Sio Silica 24 year project area and mining claims

Extraction licence denied by Manitoba Government

Feb. 16, 2024 following CEC Hearing

Pollutants injected into aquifer in compressor air

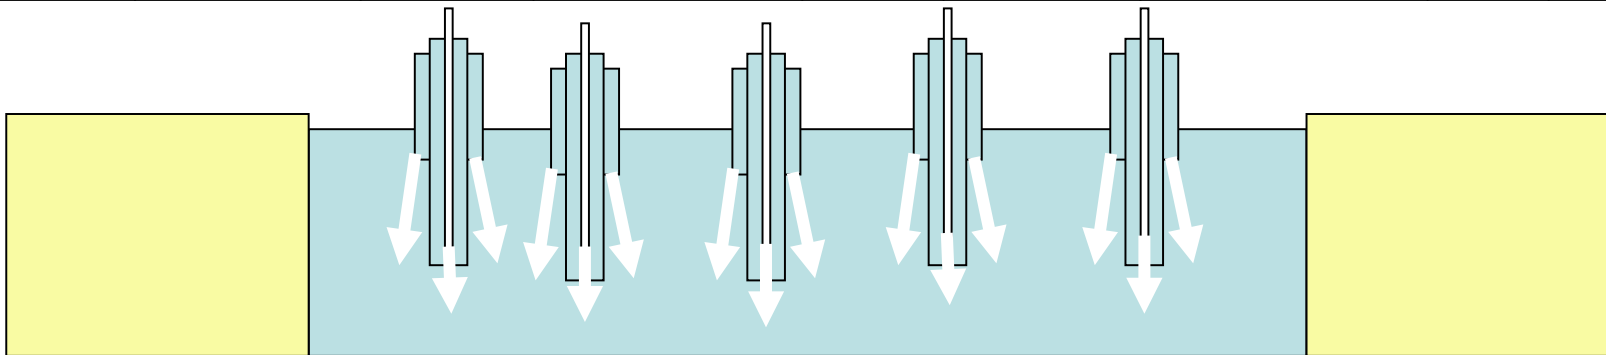
Potential contaminant concentrations in the extraction cavity for 12.84 cubic meters of diesel fuel used for each well cluster air compressor and a cavity volume of 16970 cubic meters for 3M NO₂ → 2M HNO₃ and 1M SO₂→1M H₂SO₄. Cavity volume based on 2100 tonnes of sand extracted per cluster. Diesel fuel based on 5 compressors operating for 5 days at 21.4 L diesel fuel per hour

Extraction Plan Timeline

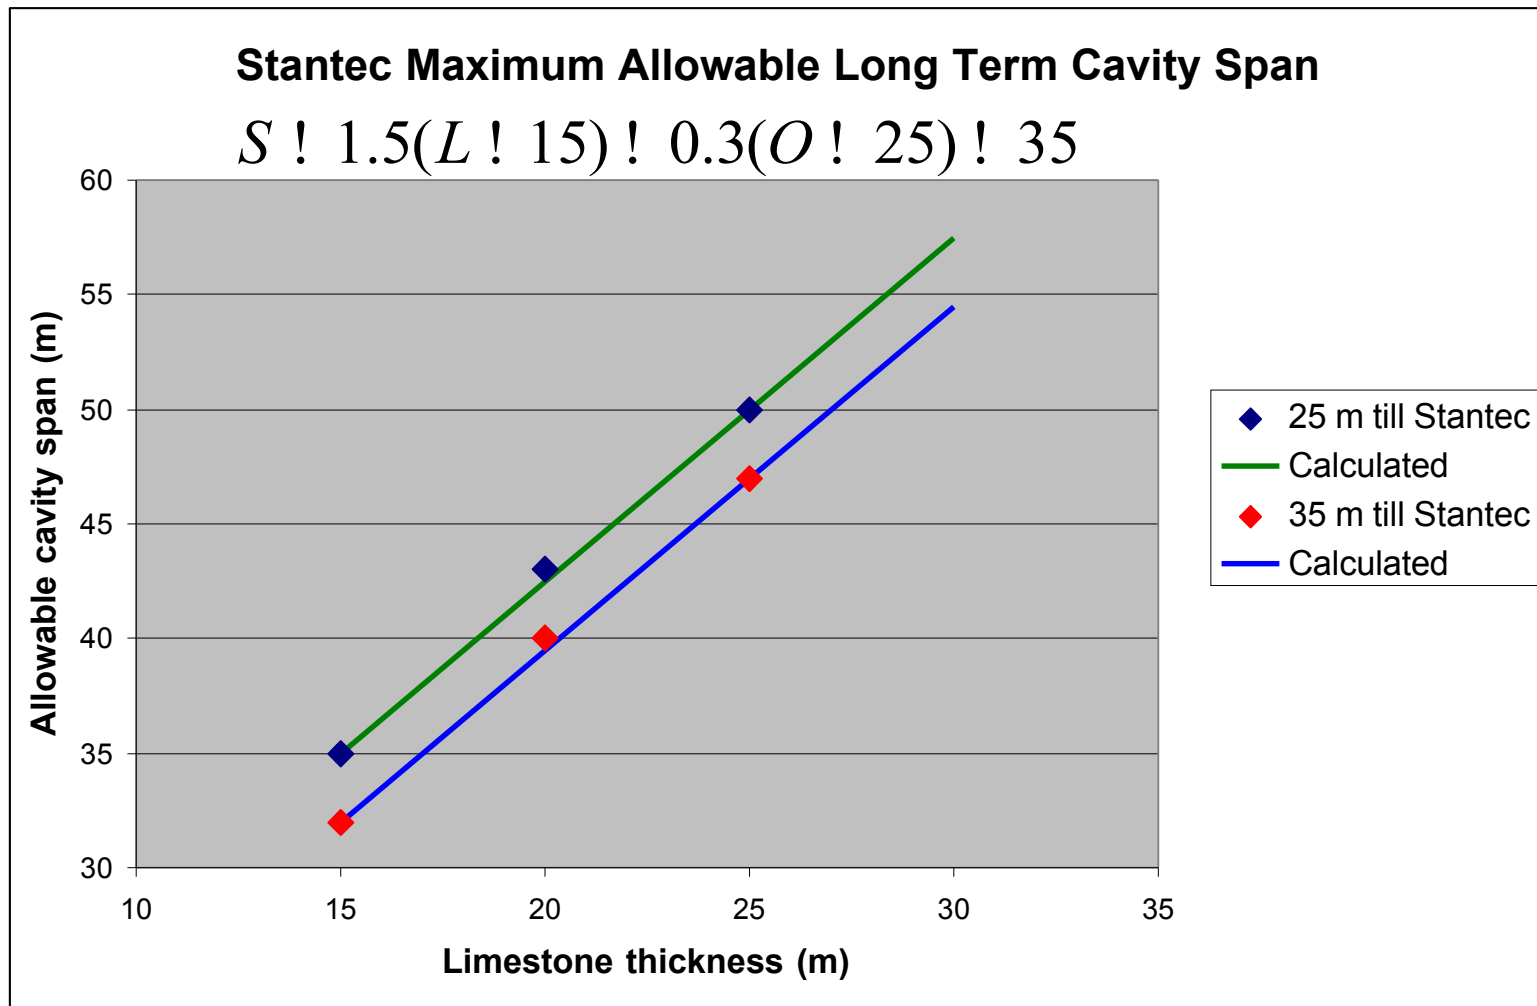
- Stantec Table 9 Data January 14, 2022 in Sio Silica Responses to Public Comments
- Supplemental Filing #1 Extraction Plan June 3, 2023 with 60 m cluster spans

- Information from 6 new wells?
- Revised Extraction Plan Jan. 24, 2023 - no 60 m cluster spans and 1-5 wells per cluster

Revised Extraction Plan

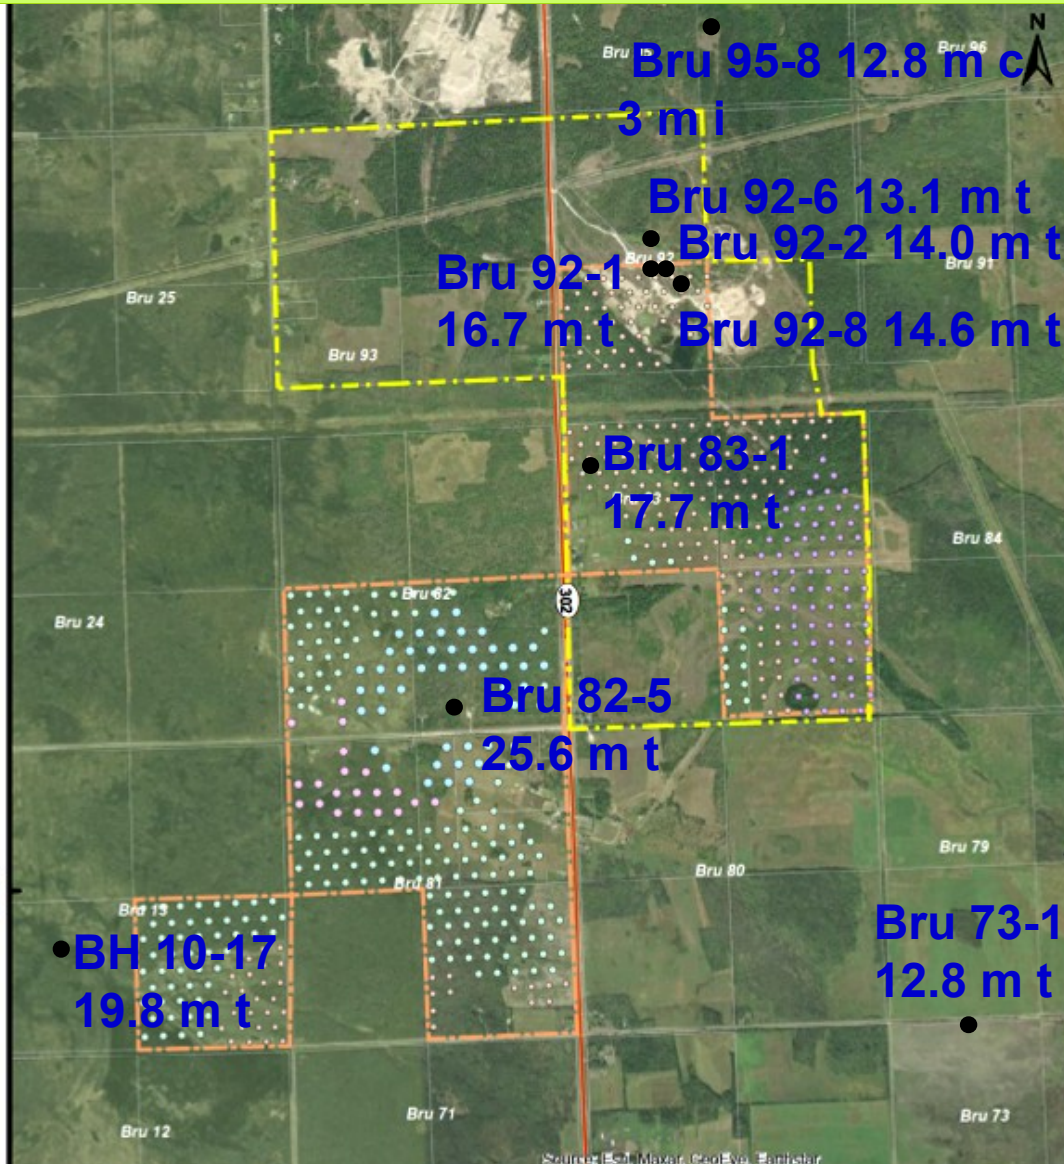
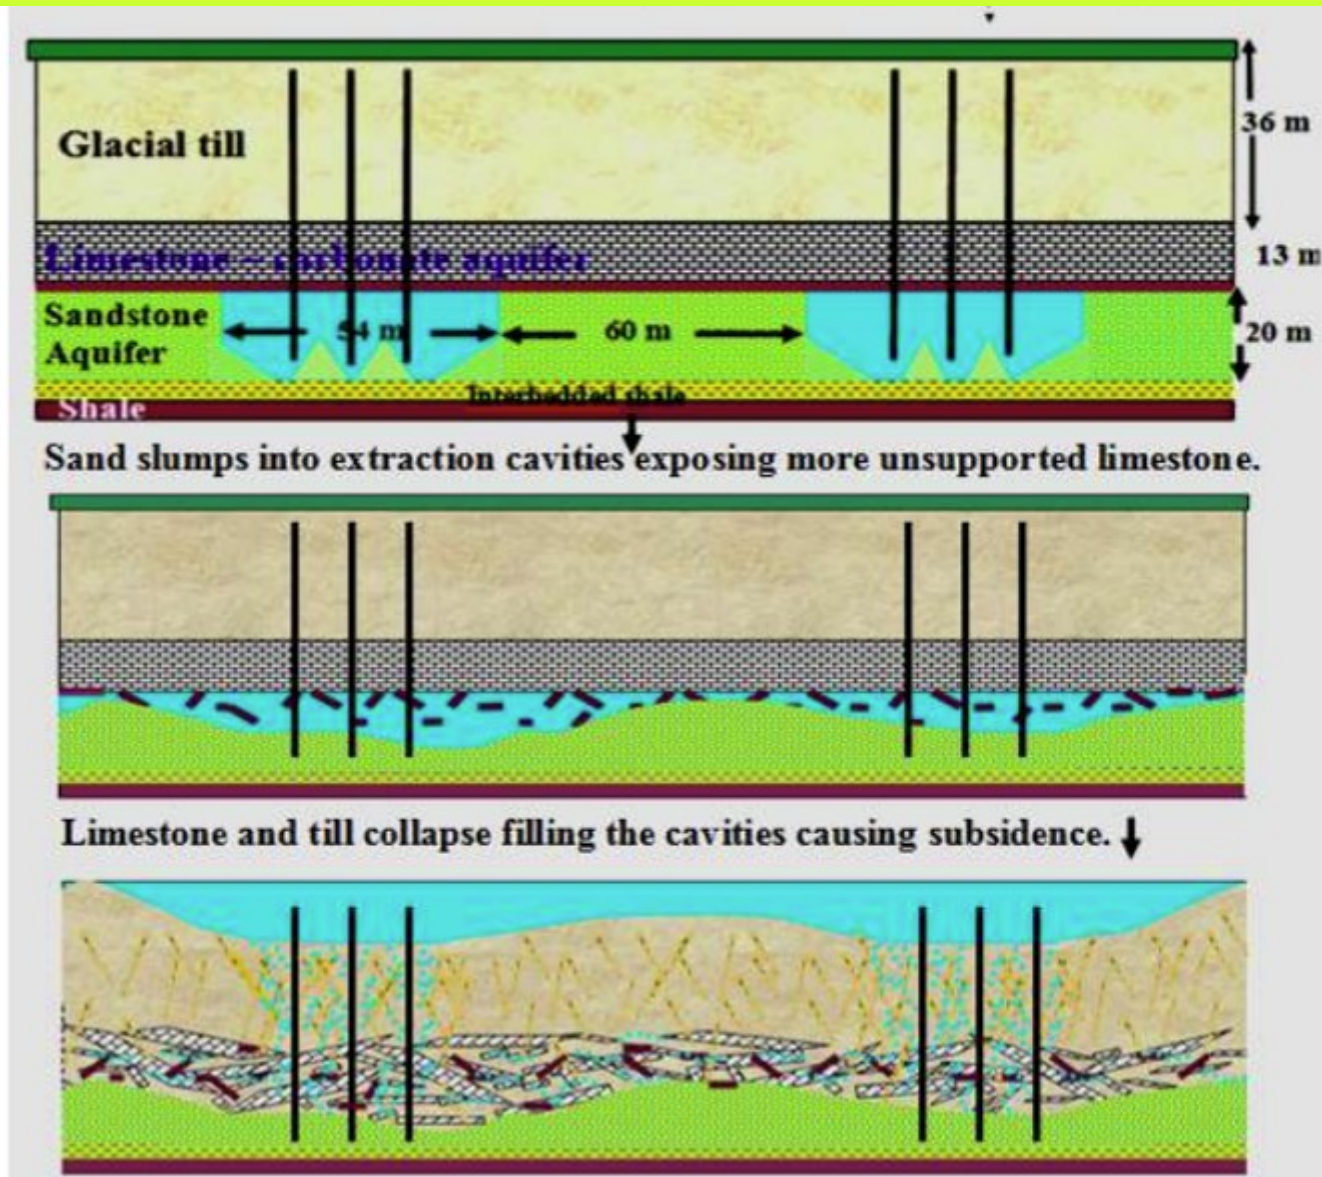
No specification of cavity span and cavity spacing

Clusters with more wells are east of those with less wells in many Bru areas

No information on cluster dates

Competent Limestone thickness east of highway 302 is less than 15 meters

Bru 92-2 Inadequate Sealing

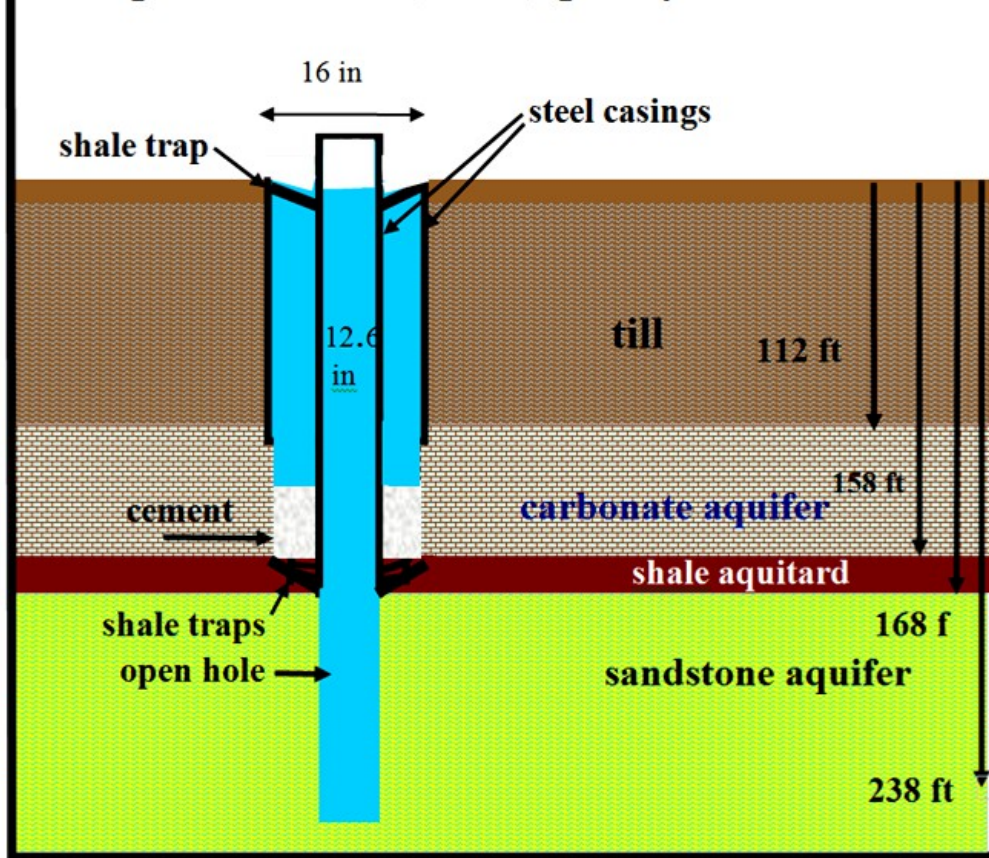
Bru 92-2 Airlift extraction well at NW29-10-8 completed June 10, 2021, quarry SW of Vivian

From	To(ft)	Const.Method	Inside Dia. (in)	Outside Dia. (in)	Material
0.0	115.0	CASING	15.5	16.0	STEEL
0.0	169.0	BOREHOLE	14.8		
0.0	168.0	CASING	12.0	12.6	STEEL
168.0	238.0	OPEN HOLE	11.0		
130.0	158.0	ANNULAR FILL	12.0	14.8	CEMENT
158.0	158.0	ATTACHMENT	12.0		K PACKER
158.0	158.0	ATTACHMENT	12.0		SHALE TRAP
0.0	0.0	ATTACHMENT	16.0		SHALE TRAP
158.0	158.0	ATTACHMENT	12.0		SHALE TRAP

Bru 92-3 Inadequate Sealing

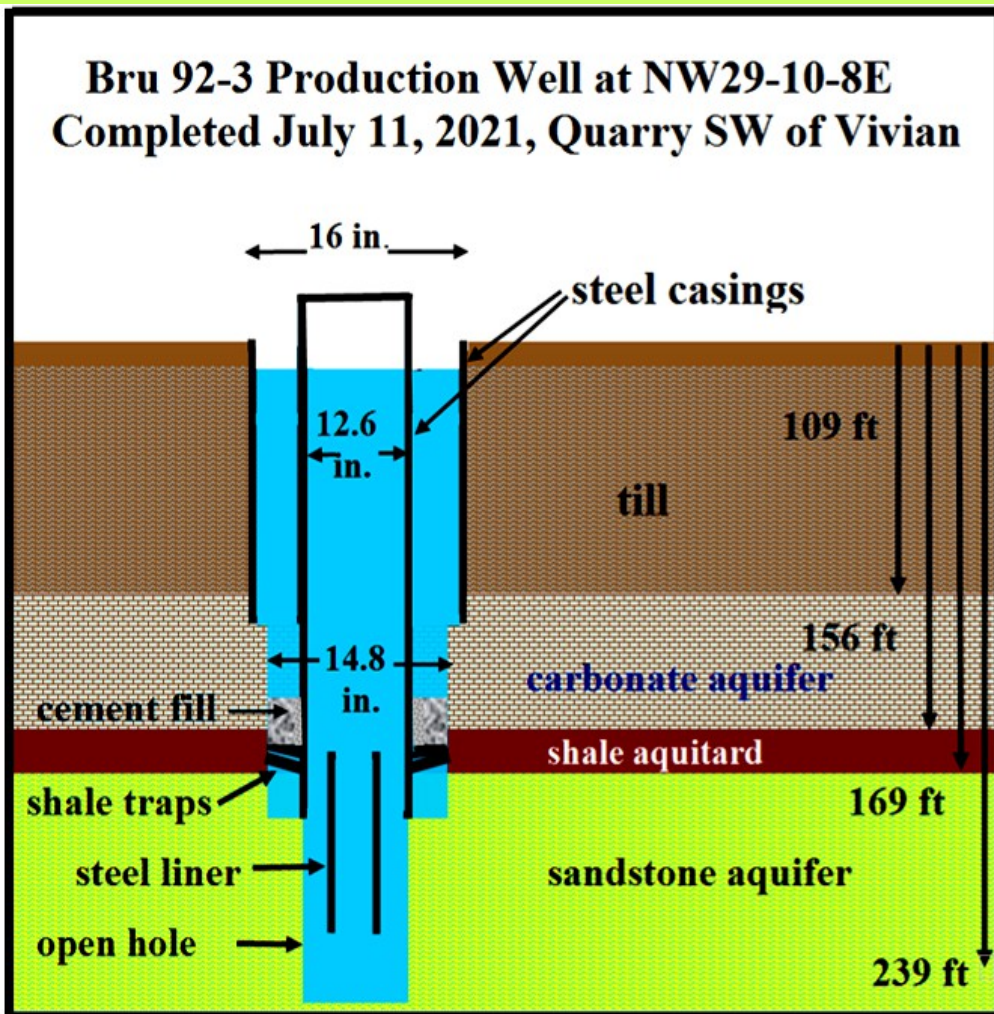
Bru 92-3 Production Well at NW29-10-8E Completed July 11, 2021, Quarry SW of Vivian

From	To(ft)	Const.Method	Inside Dia. (in)	Outside Dia. (in)	Material
0.0	115.0	CASING	15.5	16.0	STEEL
0.0	189.0	BOREHOLE	14.8		
0.0	188.0	CASING	12.0	12.6	STEEL
189.0	239.0	OPEN HOLE	11.0		
150.0	163.0	ANNULAR FILL			CEMENT
165.0	225.0	LINER	8.0	8.6	STEEL
163.0	163.0	ATTACHMENT			SHALE TRAP
168.0	168.0	ATTACHMENT			SHALE TRAP
Top of Casing: 2.0 ft above ground

Infrastructure

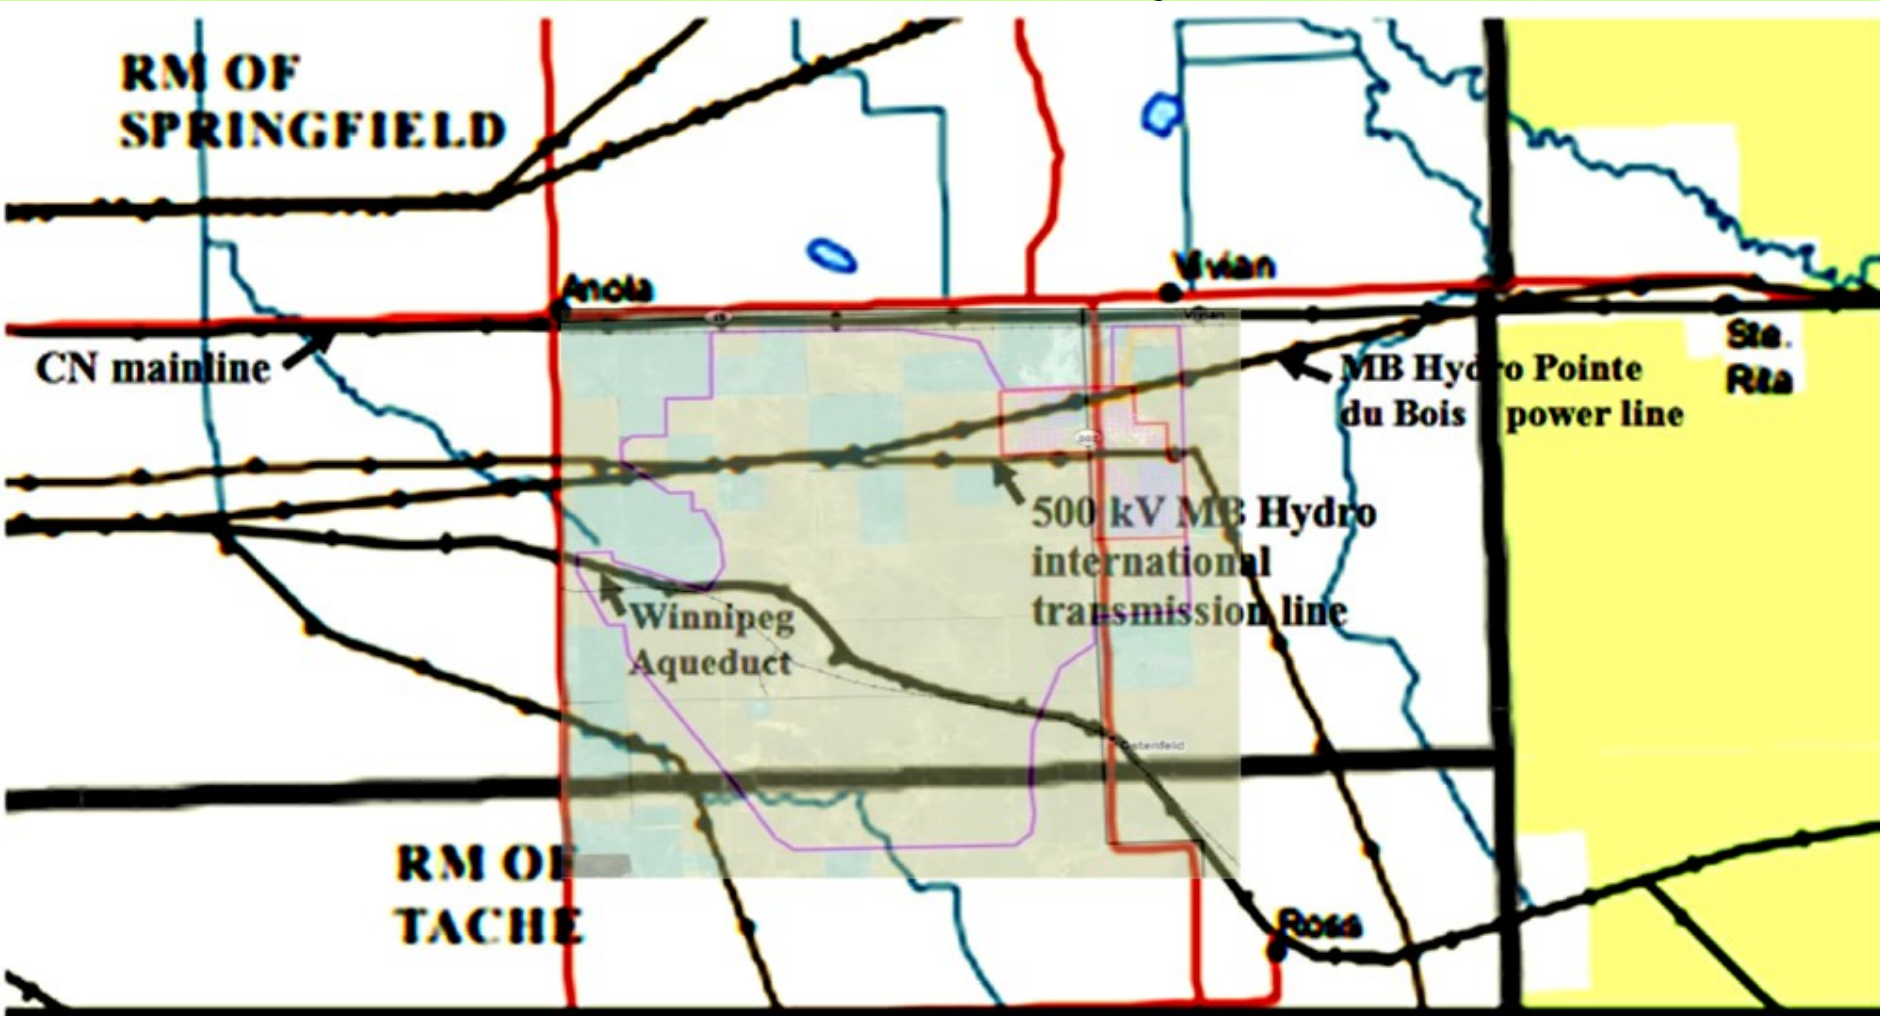
Permission required from Hydro not obtained
